Addendum # 3

Response to Vendor Questions & Revisions to IFB

**Illinois Department of Transportation (IDOT)
IFB REFERENCE NO, 2014-D1-0001
SUPER MEDIUM DUTY PARATRANSIT VEHICLES**

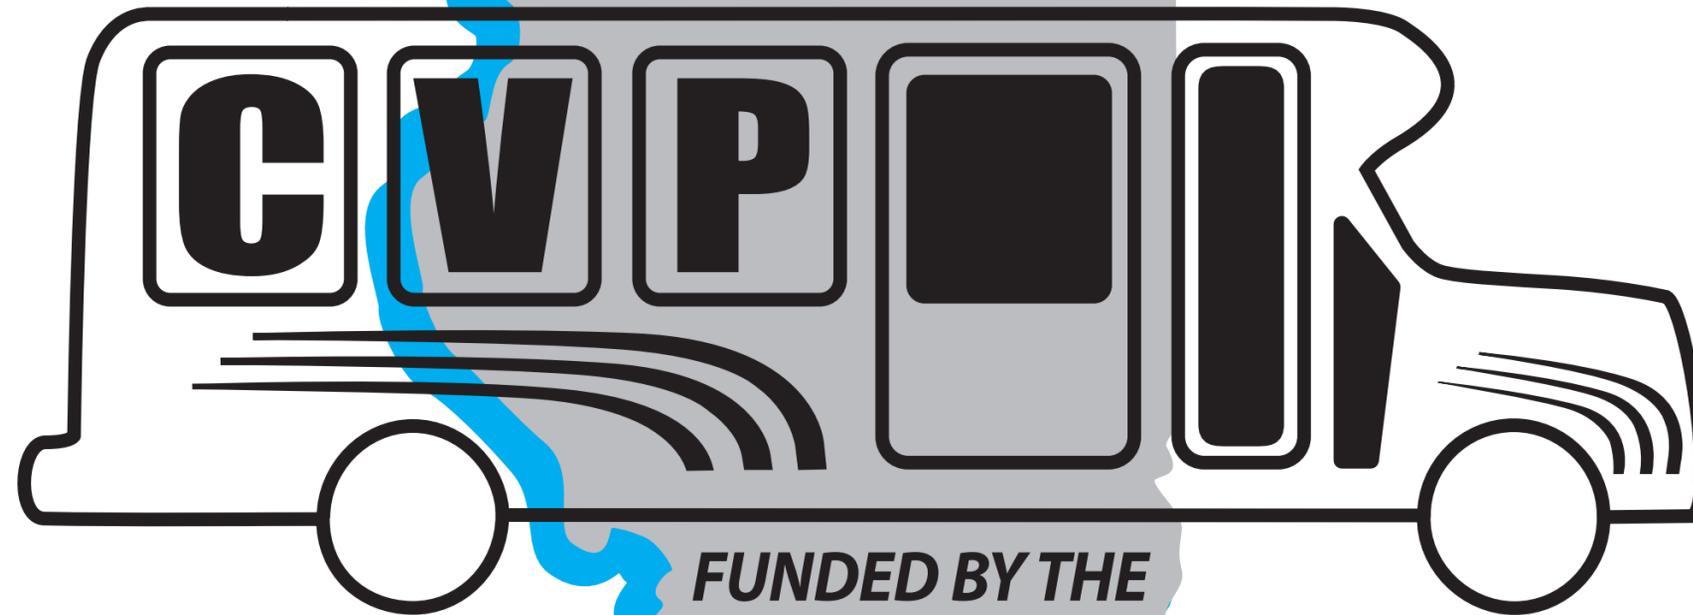
NUMBER	PAGE	SECTION	SPECIFICATION	REQUEST	IDOT RESPONSE
76	59	3.4.4.1 [3.4.3.1]	This section describes the IDOT FTA lettering to go on both sides of the buses	This is the old style lettering. IDOT has designed a new CVP decal that is located in one location on the back of the vehicles. Suggest this section be changed to reflect the new type decal and location.	In response to this request, IDOT revises Section 3.4.3.1 to read as follows: All exterior decals shall be black or white, depending upon location, elastomeric, pigmented film, die-cut, pre-spaced, with pressure sensitive adhesive. In addition to those markings specified elsewhere in these technical specifications, the decal (shown separately below) shall be provided on both sides of the vehicle. Final layout, size and location are subject to Procuring Agency approval prior to production.
77	59	3.4.4.1	Option BB: This section calls for roller type destination signs option	We recommend changing this to an electronic destination sign in lieu of the out dated roller type signs. Roller signs are not widely used any more and have some ordering restrictions that can create issues. We suggest the following specifications verbiage: "As an option, destination and route signs shall be installed on the front and boarding side of the vehicles.. The signs shall be electronic type that have high intensity LED's with automatic brightness adjustments. Programming of the signs shall be web base programmable with USB port(s) and meet ADA-compliant fonts".	In response to this request, IDOT revises Section 3.4.4.1 to read as follows: As an option, destination and route signs shall be installed on the front and boarding side of the vehicle. The signs shall be electronic type with high intensity LEDs with automatic brightness adjustments. Programming of the signs shall be web base programmable with USB port(s). In response to this request, IDOT deletes Section 3.4.4.2 All other subsections in this section remain unchanged.
